SERVICE NO. 1284B BULLETIN

LYCOMING SERVICE BULLETIN NO. 622A

DATE: March 13, 2019 Service Bulletin No. 622A
(Supersedes Service Bulletin No. 622)
Engineering Aspects are
FAA Approved

SUBJECT: Reprint of Slick/Champion Aerospace Service Bulletin SB1-15A
MODELS AFFECTED: All Lycoming engines equipped with Slick 4200, 4300, or 4700 Series (LASAR) magnetos.

Figure 5. K3008 Distributor Gear With Monel Electrode

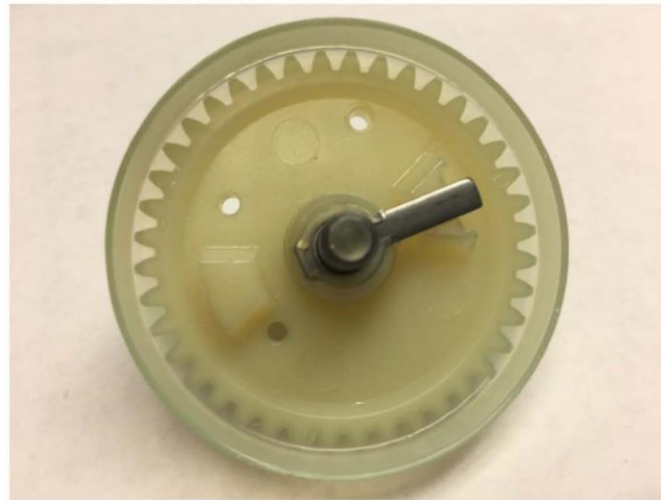
If it is not possible to confirm the version of the distributor gear that is installed in a given magneto from maintenance records, the magneto may be removed from the engine in order to have the housing and distributor block removed to allow visual inspection of the distributor gear. Distributor gears with Copper electrodes must be replaced with distributor gears with Monel electrodes.

REMOVE affected distributor gear assembly in subject magnetos and REPLACE with replacement distributor gear assembly, K3008, as soon as possible, not to exceed the next 50 hours. Document Service Bulletin compliance as written entry in applicable Aircraft and/or Engine logbook.
